LANL
LA/Pueblo Surface Water
Grade Control

From: Rodriguez, Cheryl [CRodriguez2@doeal.gov]
Sent: Friday, September 18, 2009 4:18 PM
To: Cobrain, Dave, NMENV
Cc: katzman@lanl.gov; Werdel, Nancy; Gregory, David R.; Ford-Schmid, Ralph, NMENV
Subject: DP/Pueblo Canyons Grade Control Structures Project
Attachments: C-102 - PUEBLO CANYON OVERALL WITH AERIAL.pdf; C-104 - PUEBLO CANYON EROSION CONTROL PLAN.pdf; C-200 - PUEBLO CANYON CROSS SECTIONS.pdf; C-201 - PUEBLO CANYON CROSS SECTIONS.pdf; C-202 - PUEBLO CANYON CROSS SECTIONS.pdf

CLIENT	PROJECT	TASK
LOS ALAMOS NATIONAL LABORATORY LOS ALAMOS, NM	LOS ALAMOS NATIONAL LABORATORY GRADE CONTROL STRUCTURES	PUEBLO CANYON OVERALL SITE PLAN WITH AERIAL

JOB NO 100005632
DATE 09/14/2009
DESIGNED DTW
PE RMP
CHECKED IMT
QC MS
SHEET C-102

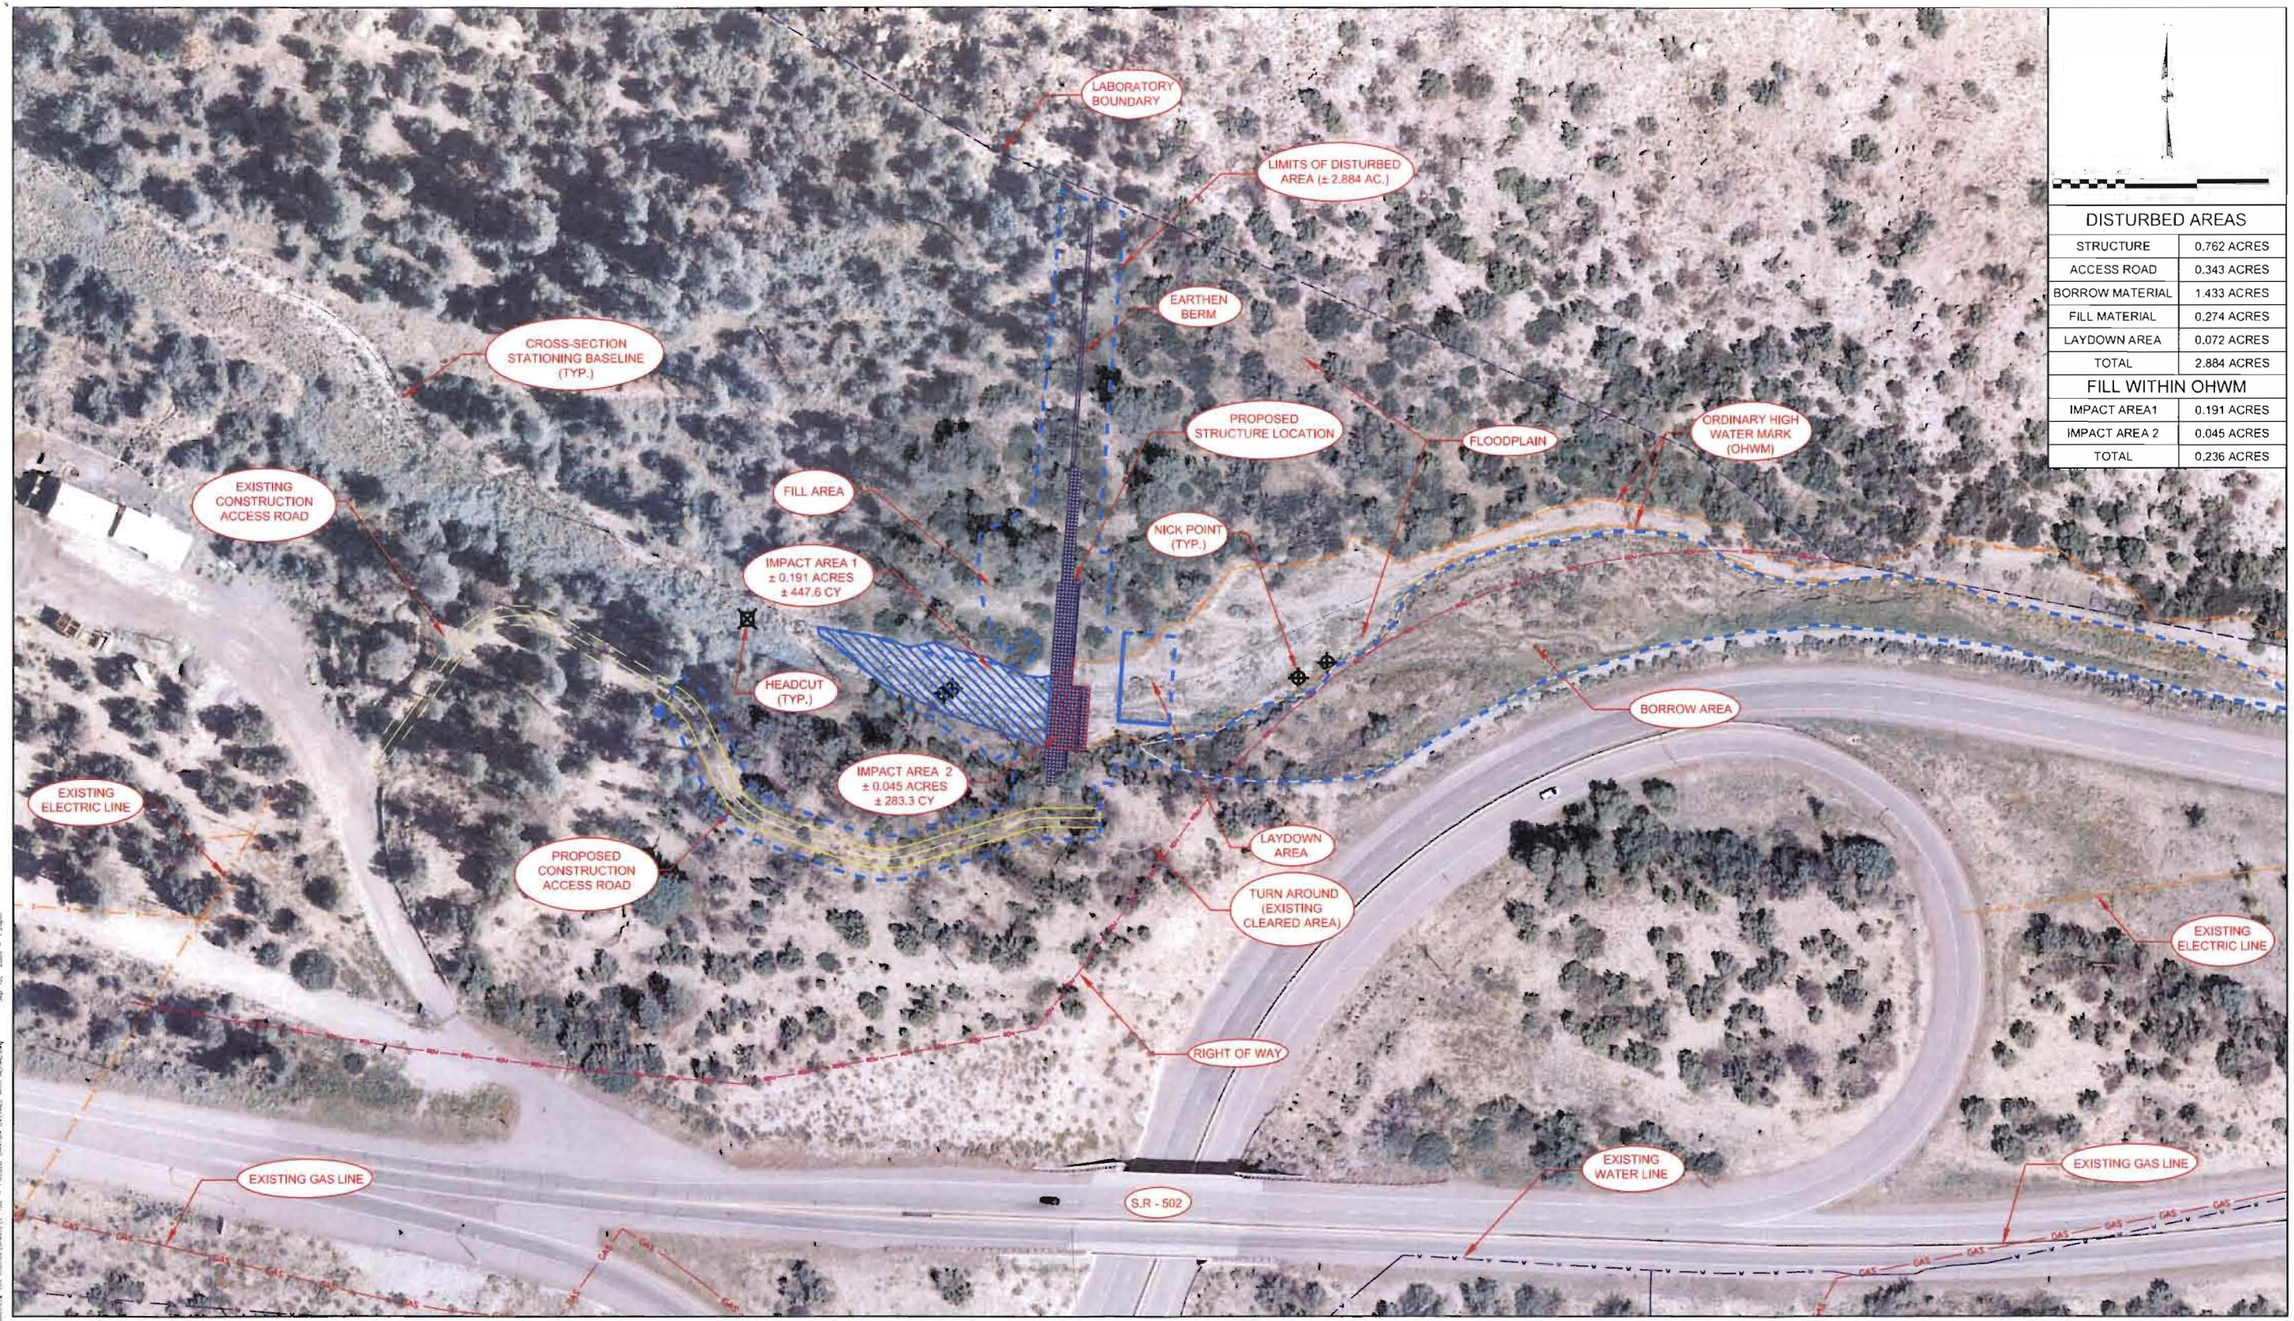
We have also identified a source for borrow material for the fill that will be placed upgradient of the structure as proposed in the design package you've received. The borrow area consists of post-Lab aged sediments located immediately down canyon of the location of the structure and is shown as a polygon on the attached map (See drawing C-104; note the area that will be targeted will not encroach on the concrete embankment along the highway). Besides being a useful source of fill material, removal of those sediments will remove it from access to erosion by floodwater that may potentially overtop the structure. Addition of fill material above the structure as part of the construction phase will also considerably accelerate ideal functioning of the wetland and maintain stability of the reused sediment within the canyon.

C
C-200 C-201 PUEBLO CANYON GABION CROSS SECTION B-B
SCALE: 1"=5'

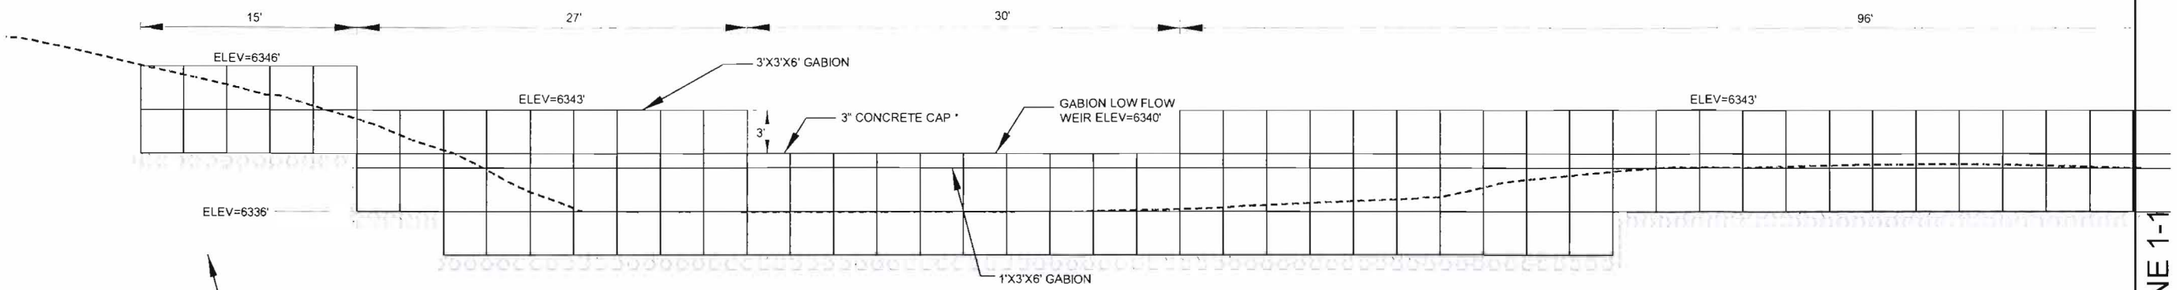
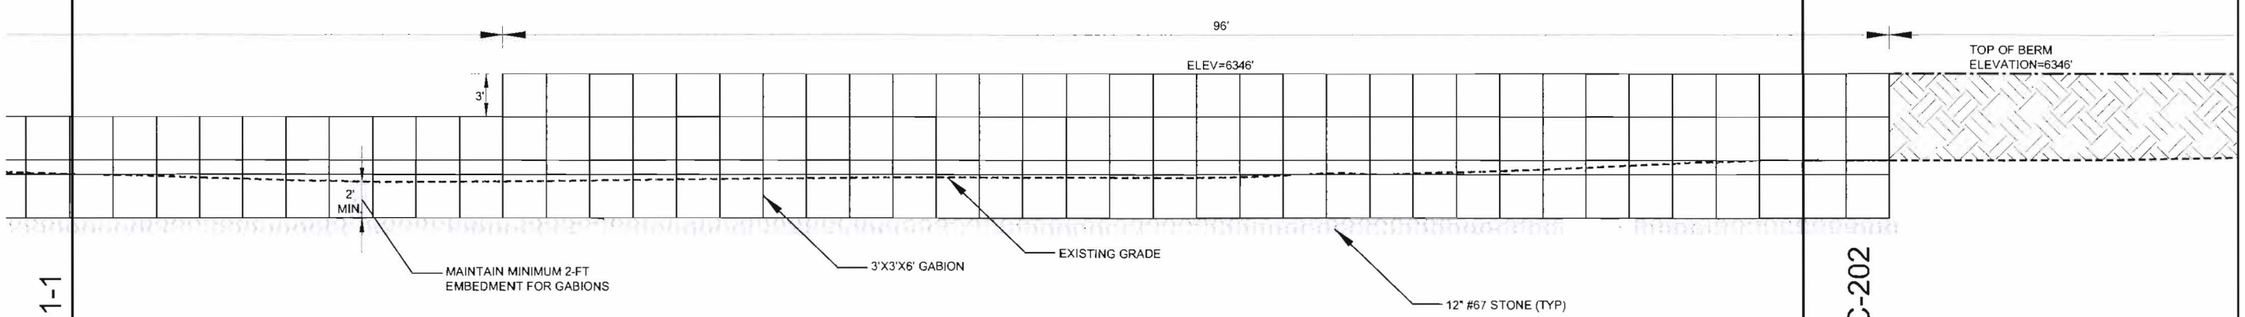
Dave-
Thanks for providing your initial observations on our engineering design submittal for the grade control structures in Los Alamos and Pueblo Canyons. Pursuant to NMED's suggestion to increase the height of the spillway of the Pueblo Canyon grade control structure by 2 ft, we have consulted with our engineering/construction subcontractors. We've determined that the adaptability of the structure enables your requested modification. We've directed the subcontractors to include the modification in the final design. As an additional note, during the review period the subcontractor has further assessed some details of the design and has recommended a modification that will have a smaller footprint, while maintaining all of the hydraulic objectives of the design. The modified design drawings are attached. Since the suggestion to increase the height of the Pueblo Canyon low flow weir was a recent request, the attached modified drawings do not reflect the change in height.
